DEPARTMENT OF HEALTH & HUMAN SERVICES

To: Administrative File, BLA STN 125555/0 Antihemophilic Factor VIII
(Recombinant), Plasma/Albumin Free

Subject: Addendum Review of the BLA submitted by Octapharma Pharmazeutika
Produktionsges.m.b.H., License 1646, for the control of bleeding episodes and
perioperative management in patients with hemophilia A

Composition of product and placebo solution, placebo solution has the same composition except factor VIII protein

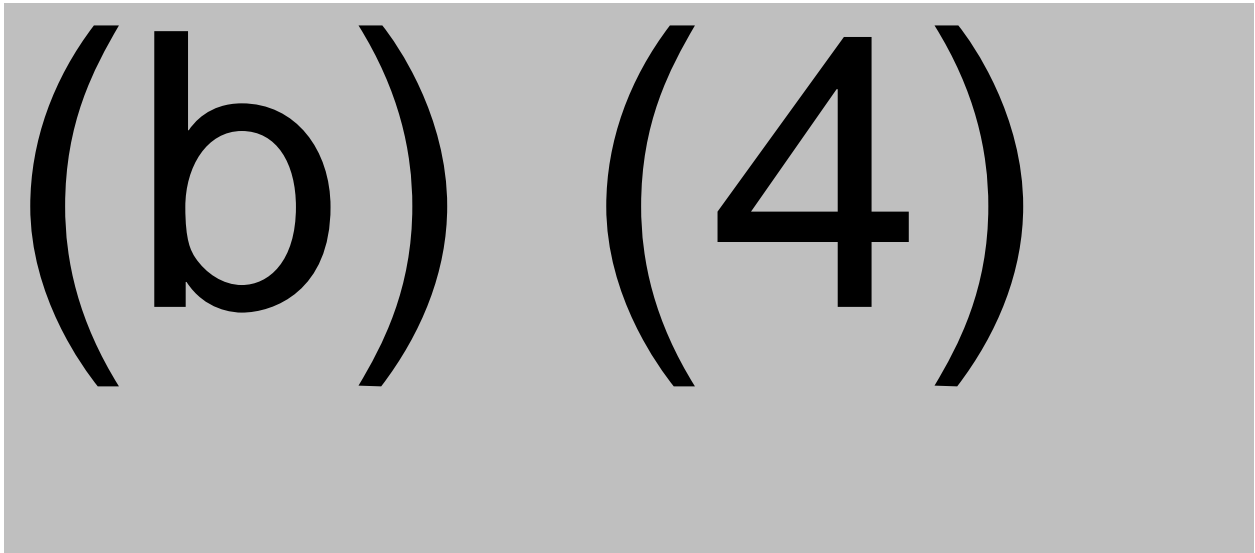
4. *Clarify if the placebo and/or product vials were temperature mapped during the minimum and maximum loads for lyophilizer (b) (4). If Octapharma used placebo in place of product for temperature mapping, please provide your rationale and data to support the use of placebo in place of product.*

This response appears acceptable. The validation data demonstrated that the freeze-drying characteristics for the placebo and product vials are equivalent regarding water content, solubility and appearance of the freeze-dried cakes. The placebo and product solution temperatures during the freeze-drying process also appear comparable.
